# State of Utah

DEPARTMENT OF NATURAL RESOURCES  
DIVISION OF OIL, GAS AND MINING

## INSPECTION REPORT

Permittee and/or Operators Name: North American Equities (NAE) (415)866-7186  
Operator's Repr.: William Prince; Holme, Robert & Owen (801)521-5800  
Business Address: 50 S. Main Street, Salt Lake City, UT 84114  
Mine Name: Blazon #1 Mine Permit Number: INA/007/021  
Type of Mining Activity: Underground XX Surface      Other       
County: Carbon  
Company Official (s): Carol A. Bjork (Operator's Consultant)  
State Official(s): Harold G. Sandbeck  
Partial: XX Complete:      Date of Last Inspection: April 18, 1989  
Weather Conditions: Cold, overcast and snowing. Two inches of snow fell.  
Acreage: Permitted 320 Disturbed 1.5 Regraded      Seeded      Bonded 1.5  
Enforcement Action:

Title of Proposal: Snyder Canyon Small Area Exemption (SAE)

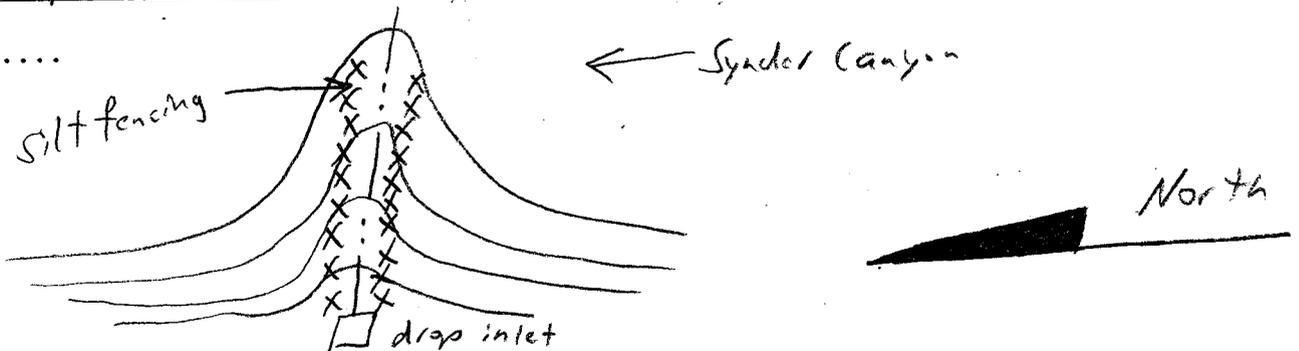
Description of Permit Change: Identify the north and south slope drainages of Snyder Canyon east of the drop inlet as a (SAE) in the MRP (applicable maps and narrative). Treatment shall

Consist of silt fencing at the base of the north and south slopes of Snyder Canyon.

Due date for submittal of revised application pages and maps: June 21, 1989 including installation of Silt Fencing.  
 Submittal should include ~~eight~~ <sup>three</sup> copies of: Refer above to "Description of Permit Change"
